Application Serial No. 10/777,782
Amendment in Response to Action dated September 5, 2006
Page 2 of 18

Amendment to the Drawings:

U.S. Patent Application No. 10/777,782
Annotated Sheet

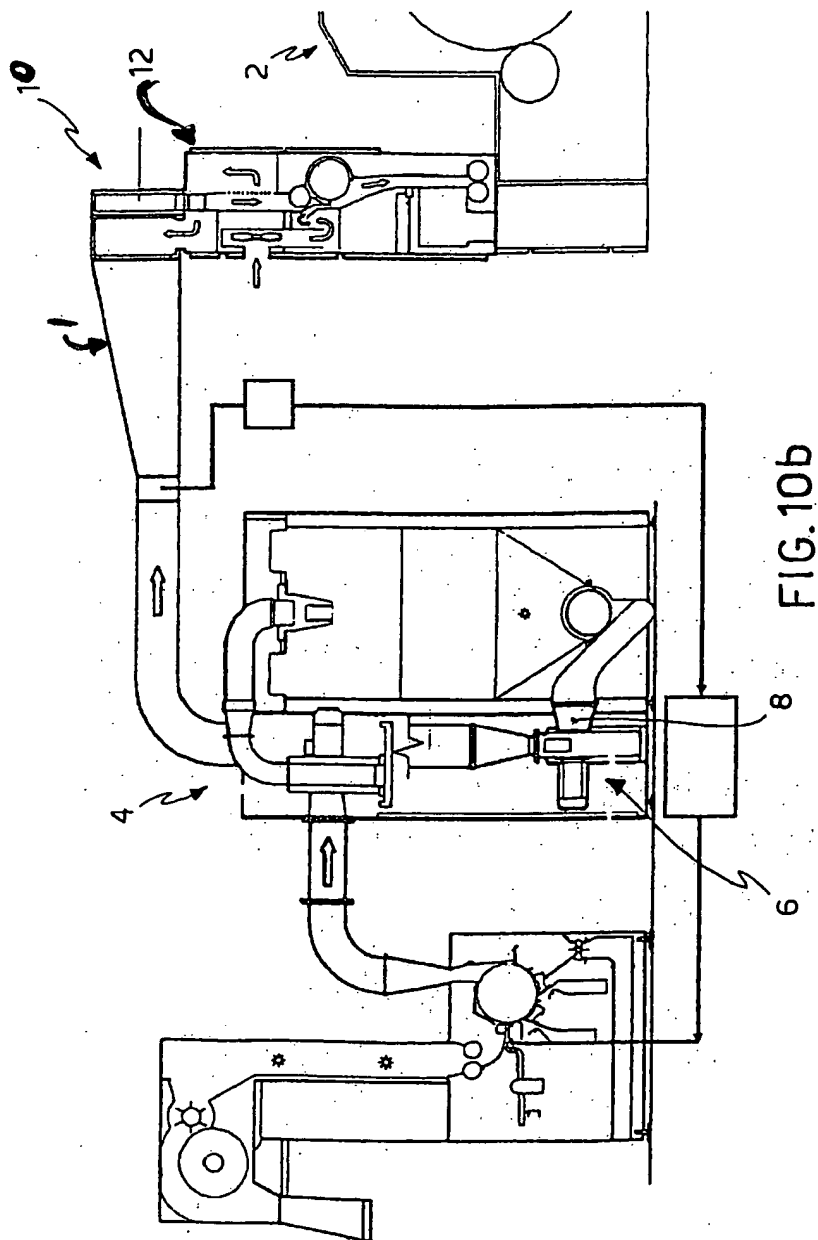
The attached drawings sheets include changes to FIGS. 10A -10B and FIGS 11A-11C.
Specifically, omitted element 10 has been added, as described in the specification.

Applicants propose to amend Figures 10A-10B and 11A-11C to add omitted element 10 (the distributor/connector) and to correct the locations of elements 1 (air ducts), 2 (carding machine), and 12 (down shoot to the Carding Machine 2). In particular, the figures have been amended according to the specification at pages 4 and 5 that describes the carding machines 2 as being connected in a substantially linear series to receive a singular air flow along the air ducts 1. the connector 10 connects the air ducts 1 to the down shoot 12 of carding machine 2.
